UNITED STATES  
NUCLEAR REGULATORY COMMISSION  
WASHINGTON, D. C. 20555

SAFETY EVALUATION BY THE OFFICE OF NUCLEAR REACTOR REGULATION  
RELATED TO AMENDMENT NO. 138 TO FACILITY OPERATING LICENSE NO. DRP-31  
AND AMENDMENT NO. 139 TO FACILITY OPERATING LICENSE NO. DPR-41  
FLORIDA POWER AND LIGHT COMPANY  
TURKEY POINT UNIT NOS. 3 AND 4  
DOCKET NOS. 50-250 AND 50-251

FIGURE 2-1  
4160V ADDITIONS

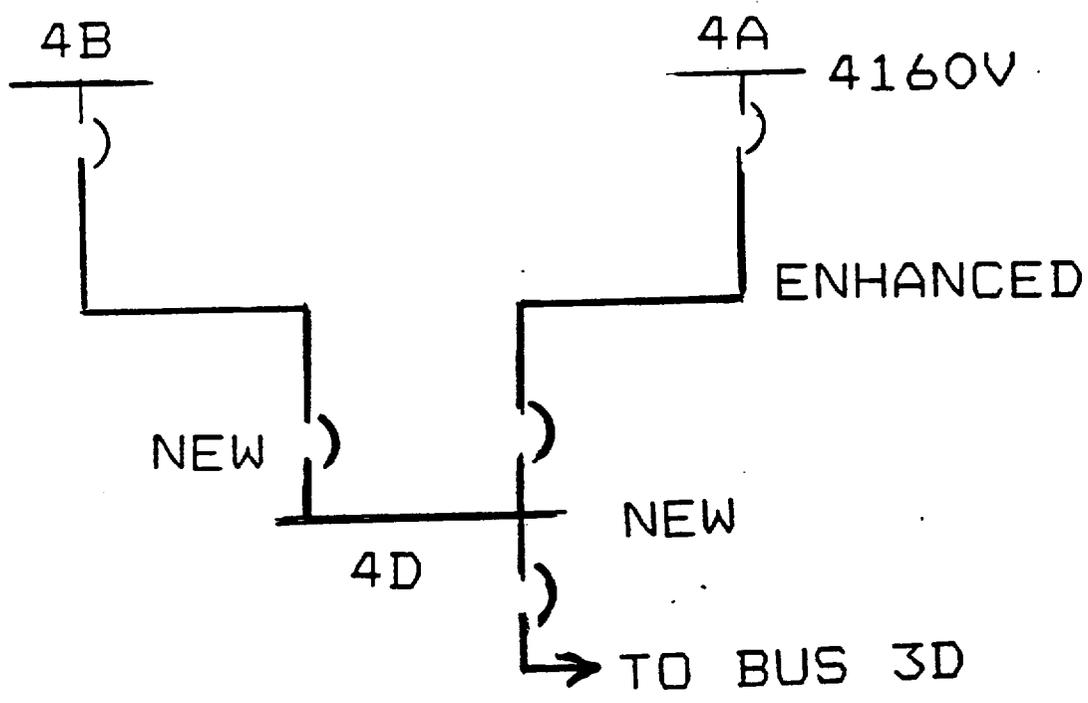
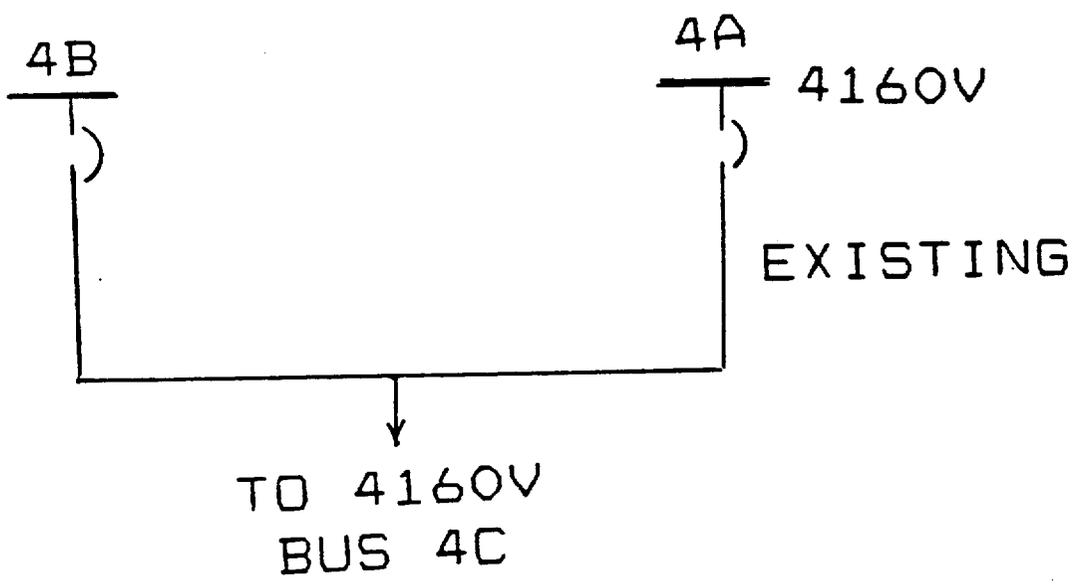
For unit 4, a new 4160V swing bus 4D will be connected to existing buses 4A and 4B. Similarly, a new 4160V swing bus 3D will be added to Unit 3 (see Figure 2-1). The swing buses power installed spare loads (i.e., component cooling water [CCW] or intake cooling water [ICW] pumps) when they are required to replace a non-operable Division A or B component cooling water pump or intake cooling water pump. The breaker cubicles in switchgear 3A/4A and 3B/4B previously supplying CCW 3C/4C and ICW 3C/4C pump motors will be reassigned as the power feeds to 4160V buses 3D/4D.

For a station blackout scenario, a new crosstie between buses 3D and 4D will be provided, including new tie breakers, one on bus 3D and one on bus 4D, to permit a manual crosstie between generating units 3 and 4. These tie breakers

will normally be open. The control circuitry includes permissives and interlocks to prevent inadvertent closure of the crosstie breakers. When the required permissives are satisfied, administratively controlled key-lock operated control switches (one for each unit) in the control room will permit closure of the tie breakers. Breaker indicating lights are provided in the control room.

FIGURE 2-2  
480V ADDITIONS

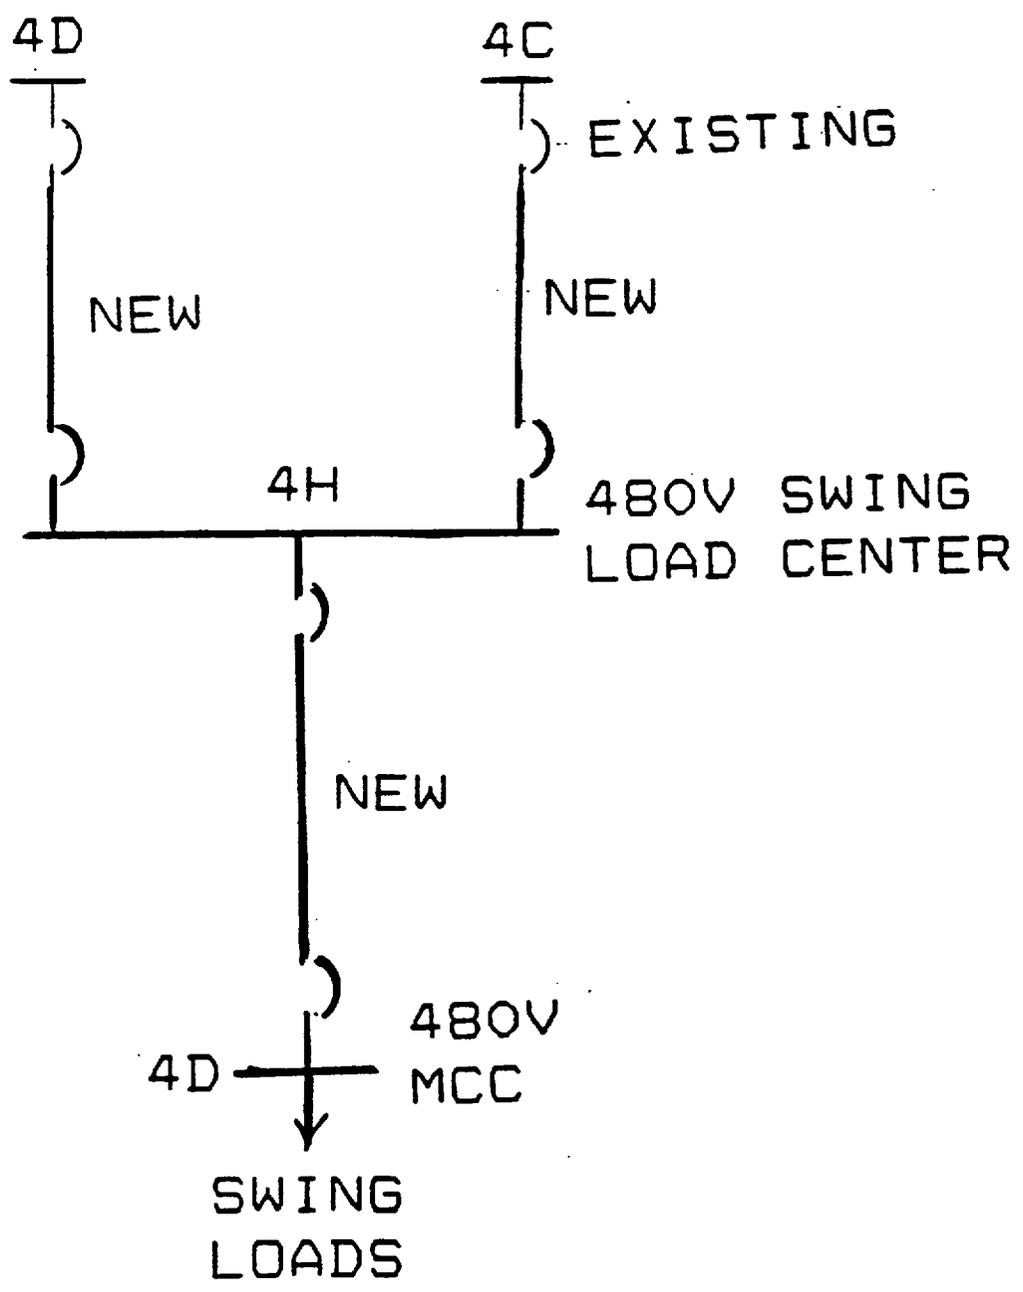
For unit 4, a new 480V load center swing Bus 4H powered by existing 480V load centers 4C or 4D is being added. Similarly for Unit 3, a new 480V load center swing Bus 3H powered by existing 480V load centers 3C or 3D is being added. Each of the two tie lines to the 480V swing buses have two breakers (See Figure 2-2). The breakers will have position indication in the main control room. Each swing load center can be aligned to either Train A or Train B of its associated unit. For each 480V load center, if the bus to which it is connected loses power, automatic circuit breaker operation connects the bus to the other power source if power is available there. The breakers have interlock logic to prevent simultaneous connection of the swing bus to Divisions A and B.

RG 1.6 discourages the automatic transfer of safety loads from one power source to another. It is preferred that there is sufficient redundancy in the loads that an automatic transfer is not required. However, such redundancy does not always exist at older plants. As compared to the existing situation at Turkey Point, the addition of the 480V swing bus improves reliability by quickly re-energizing needed safety loads upon loss of power from the primary source. The automatic transfer should occur rarely and the interlock arrangement will prevent the inadvertent connection of two 480V trains. We therefore find the 480V swing bus addition to be acceptable.

FIGURE 2-3  
125 DC BUSES

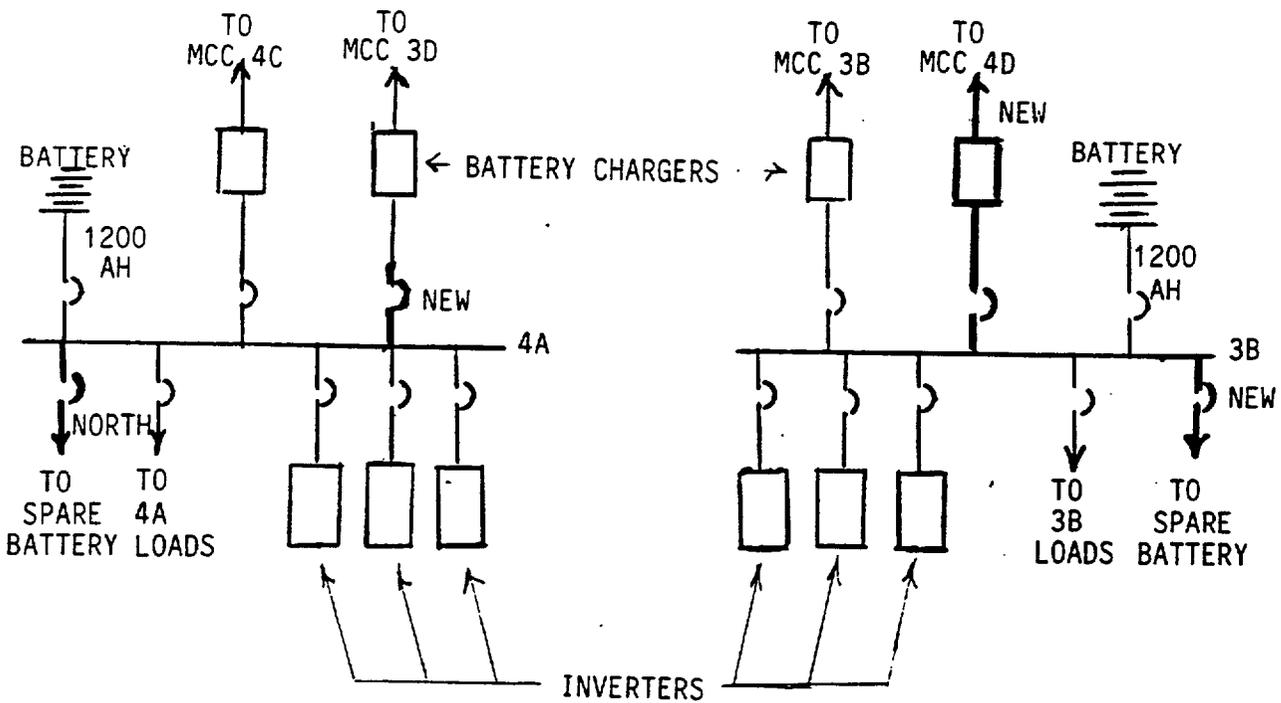
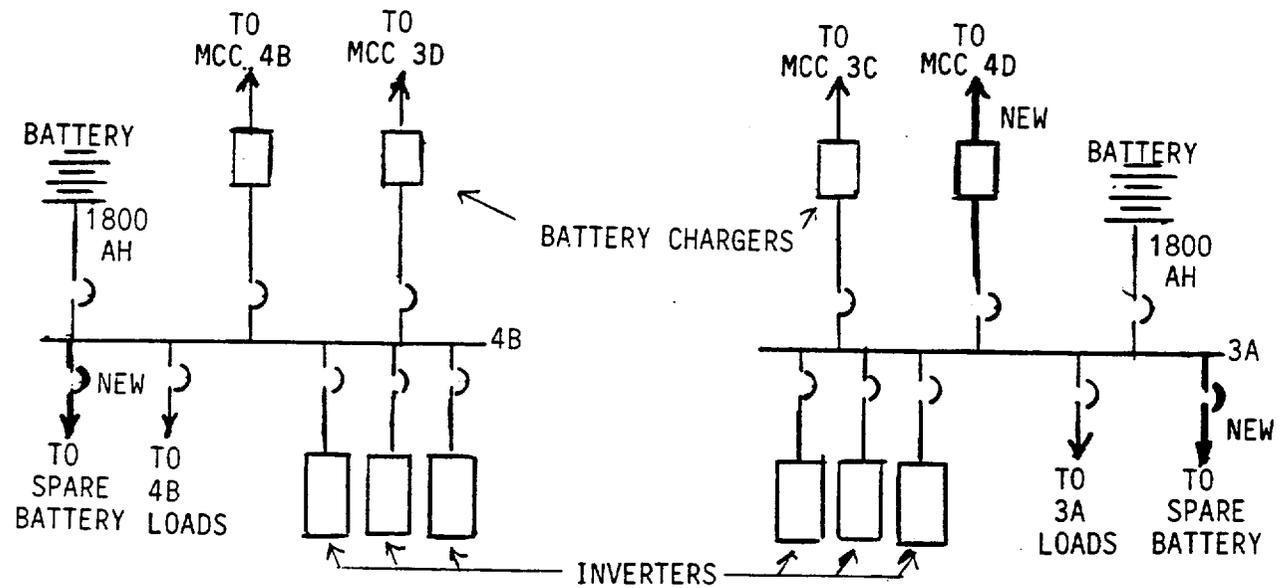
The existing six battery chargers are being replaced and two new battery chargers are being added such that each dc bus will have two full capacity chargers. One of the chargers on each dc bus will be powered from a motor control center from the same unit and division (i.e., the battery charger to dc bus 3A will be powered from a unit 3, Division A MCC, etc.). The second battery charger on each dc bus will be powered from the swing MCC from the other unit (i.e., the second battery charger to dc bus 3A will be powered from MCC 4D, etc.) After the system changes, each 125V dc bus will have two battery chargers; one supplied from each unit (See Figure 2-3).

FIGURE 2-4

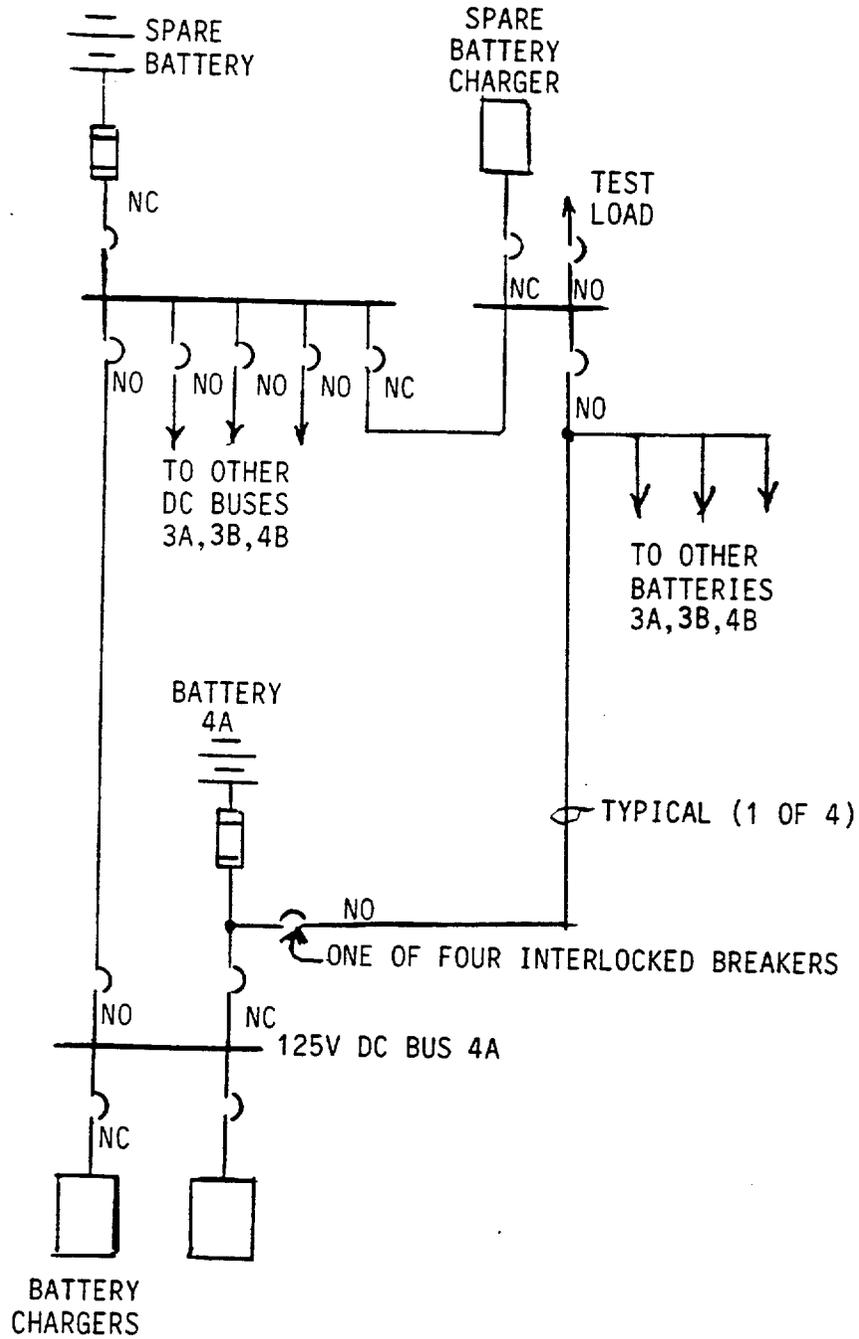
Presently, 125V dc buses 3A and 4B have a normally open tie between them which may be temporarily closed when testing either battery. A new Class 1E spare battery will be added with provisions for connecting to each 125V dc bus. Non-automatic circuit breakers with kirk key locks will prevent the spare battery from being connected to more than one 125V dc bus at a time (see Figure 2-4). The spare battery will be used to power a 125V dc bus while the normal dedicated battery is being tested and recharged (e.g., for the performance discharge or battery capacity tests). The spare battery will first be paralleled with the normal battery using the key-locked breaker. Then, the normal battery will be disconnected from the 125V Class 1E bus and connected to the test load (see Figure 2-4).
